BULLETIN # 17

PROJECT: Harrison Recreation & Community Center – PHASE 2
Harrison, NY

RE: Revised Garage Door

Sheet No.
ASK-21

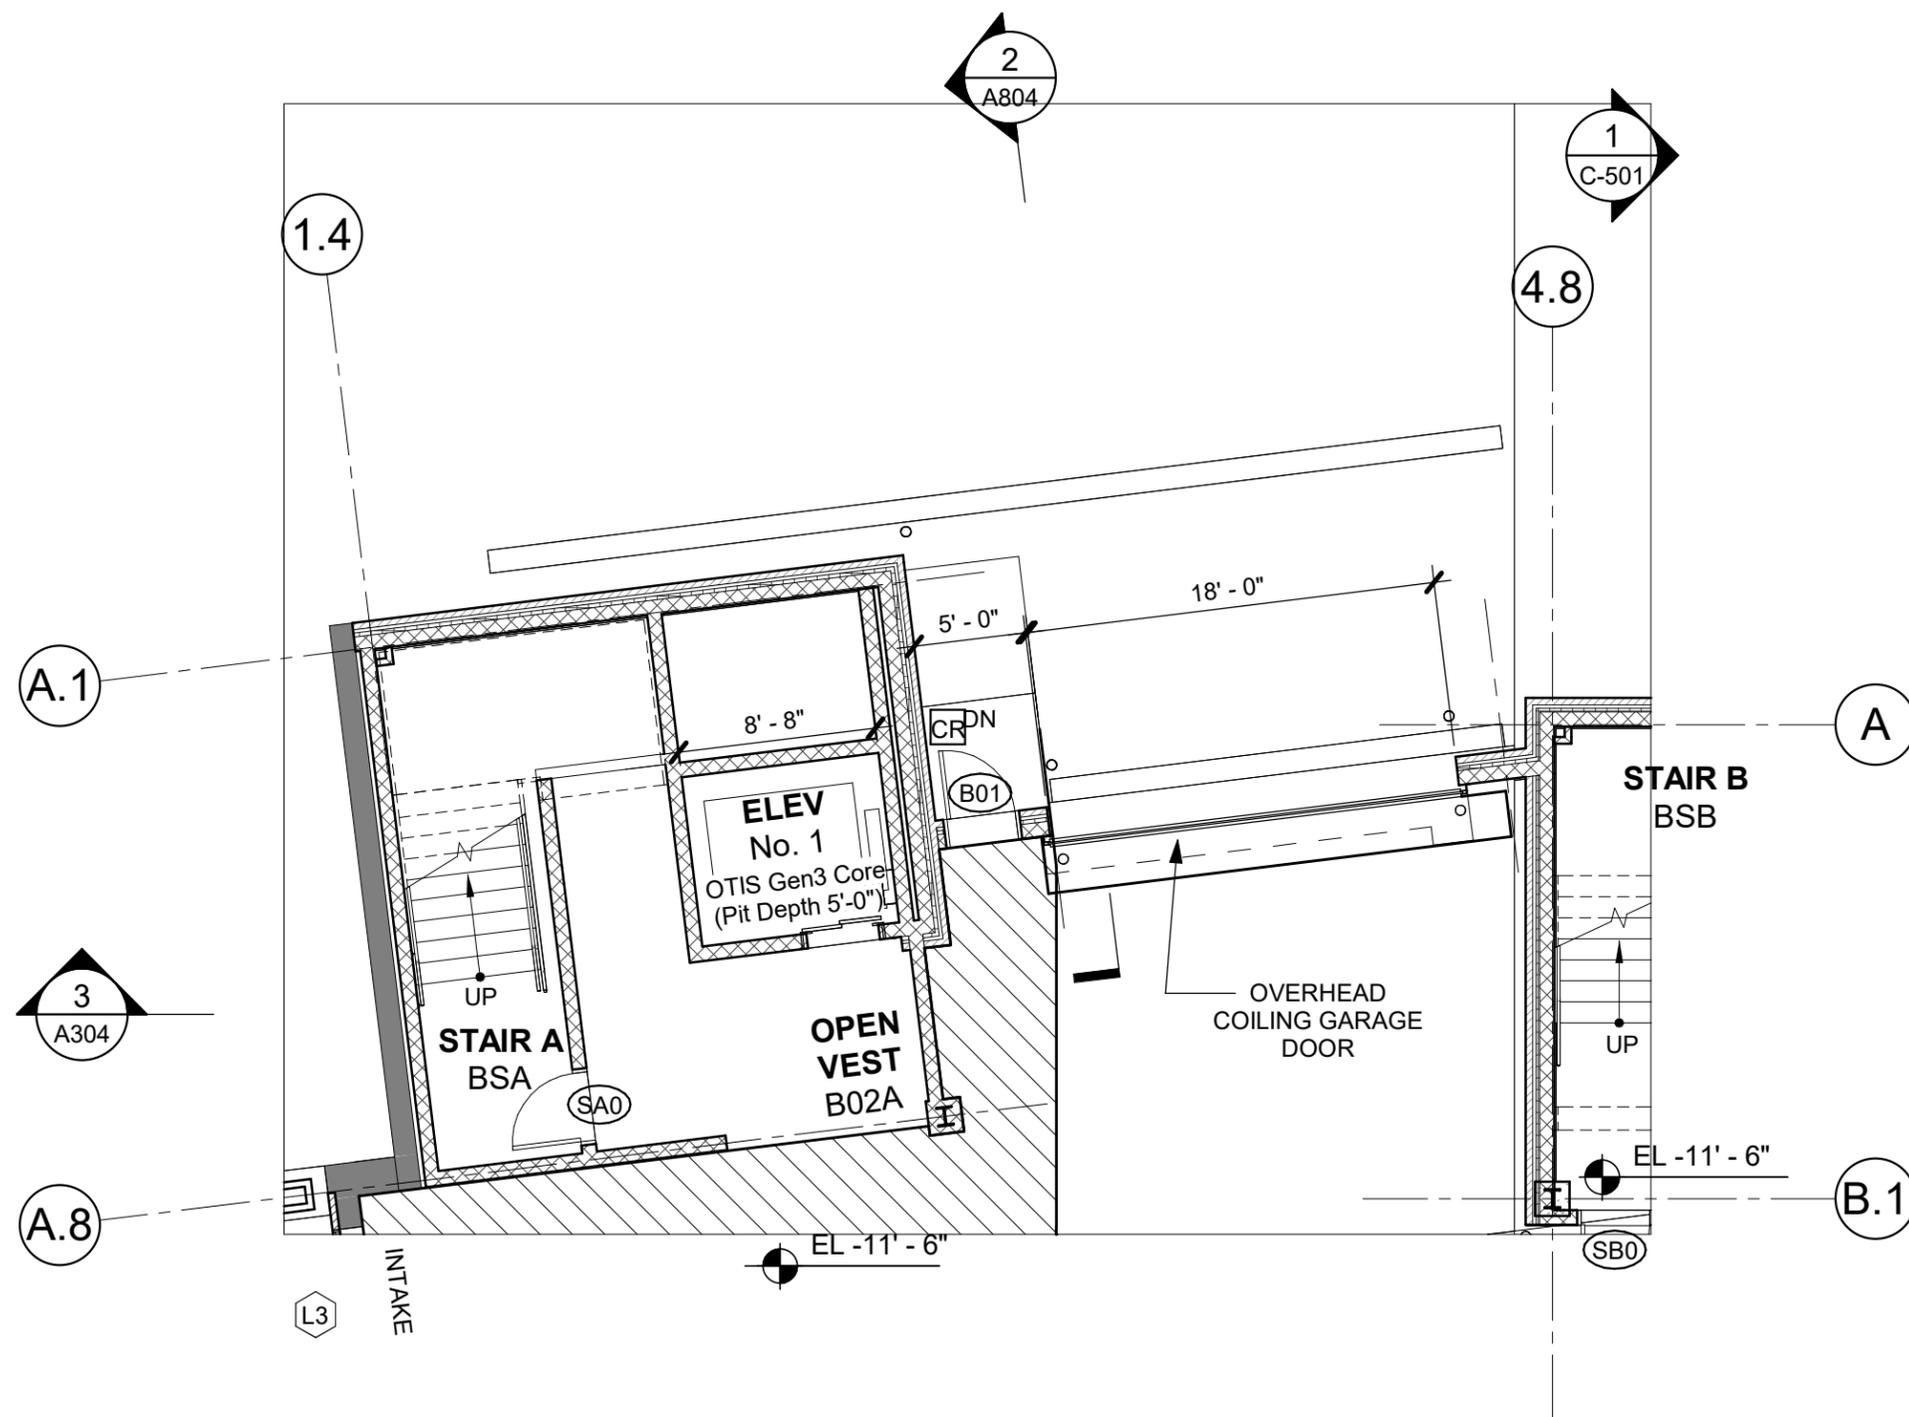
Please see the attached ASK-21 for the revised garage door size. The door is to be 18'-0" wide ILO the specified 20'-0" to accommodate the coiling door apparatus mounted above and to the side of the masonry door opening. The masonry opening has been reduced accordingly.
